LOCAL PLANNING PANEL – THE HILLS SHIRE COUNCIL

DETERMINATION OF THE LOCAL PLANNING PANEL ON 16 NOVEMBER 2022 – DETERMINATION MADE ELECTRONICALLY

ITEM 1: LOCAL PLANNING PANEL – PLANNING PROPOSAL – 21-23 VICTORIA AVENUE, CASTLE HILL (4/2021/)

This report presents the planning proposal for 21-23 Victoria Avenue, Castle Hill (4/2021/PLP), to the Local Planning Panel (LPP) for advice, in accordance with Section 2.19 of the *Environmental Planning and Assessment Act 1979*.

Figure 19
Section of development concept with potentially appropriate building forms outlined in blue

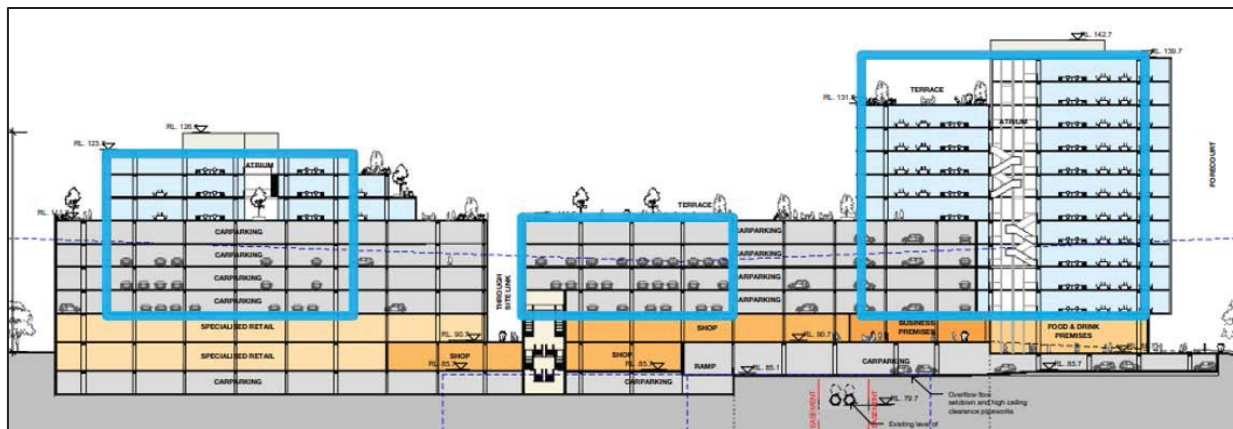
Council officers have marked up a diagram below to indicate potentially appropriate tower building envelopes that could result in a more acceptable built form outcome in this context of this site and the current and future character of the locality. It is noted however that this outcome would accommodate substantially less gross floor area (and associated parking areas) within the building envelopes in comparison to that being sought by the Proponent. The Proponent has previously been advised that consideration should be given to reducing the extent of FSR sought in order to relieve these built form issues.

Figure 21
Proposed setback controls within Proponent's draft site specific DCP

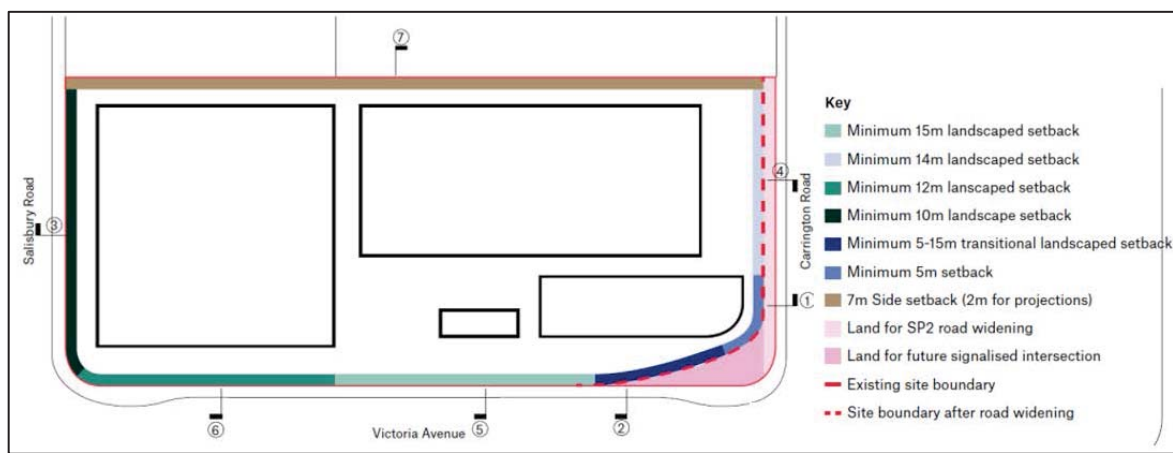
The development concept indicates setbacks of 10m-15m to the street, as shown below. Consistent setbacks have been applied throughout the locality to deliver a consistent streetscape with substantial landscaping and an attractive public domain. The proposed DCP controls would result in a development that is inconsistent with the controls that neighbouring development would be required to comply with. However, as the planning proposal will result in change of character across the site from industrial/specialised retail premises to high density commercial, it is considered potentially appropriate that the front and side setback outcomes are reduced marginally, because of the role they play transitioning uses along Victoria Road.

The proposal also seeks to provide a 7m setback to the rear boundary with 2m for projections (when the Industrial DCP would requires 5 metres). The rear setback is considered to be sufficient for creating building separation to the neighbouring development at the lower levels, however when considering the rear interface in its entirety, it is overcome by the impacts of excessive height, length and building bulk, as detailed previously in the report.

The planning proposal would be improved by DCP controls requiring greater building separation, more detailed articulation zones, visual analysis to illustrate perceived bulk from

Figure 24
Through Site link intersected by emergency vehicle lane

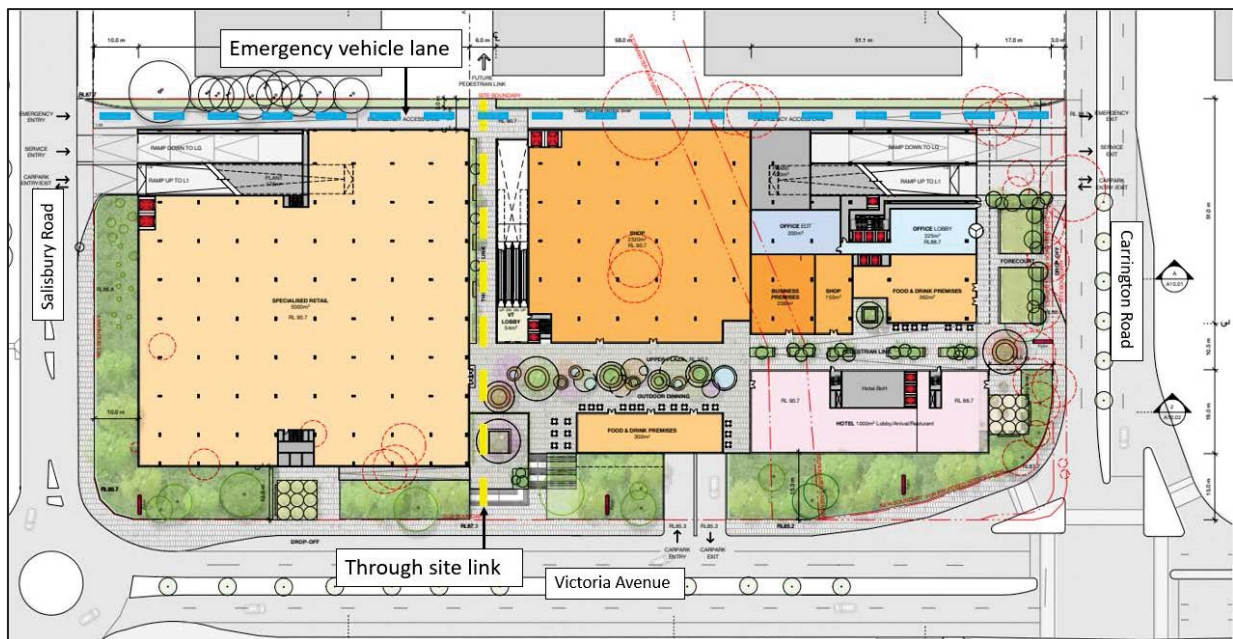
- The proposed through site link is inconsistent with the design criteria in the Showground Station Precinct DCP controls, including being clearly identifiable as a publicly accessible pedestrian link, encouraging pedestrians to move along the link and not linger; ensuring adequate passive surveillance is provided, having adequate lighting to improve safety and appropriate building setbacks.
- The through site link is intersected by a service/emergency access road along the rear boundary of the site, which will inhibit pedestrian movements and potentially be dangerous as pedestrians will interact with delivery, service or emergency vehicles.

Any revised proposal should provide a through site link that demonstrates consistency with the Showground DCP, is at grade, does not intersect with a service road, be accessible for people with a disability or in wheelchairs and be easily identifiable, welcoming and encourage pedestrian use. Further consideration and prioritisation of the through site link in the design of the development is needed to positively contribute to the pedestrian infrastructure and permeability. The management of the service land and its relationship with the through site link could potentially be addressed through measures such as timed service vehicle access or boom gates, however this would be a last resort to rectifying the site planning issues identified within this report as part of the planning proposal application. Furthermore, the viability of this type of arrangement would likely depend on the final make-up of uses within a future Development Application.
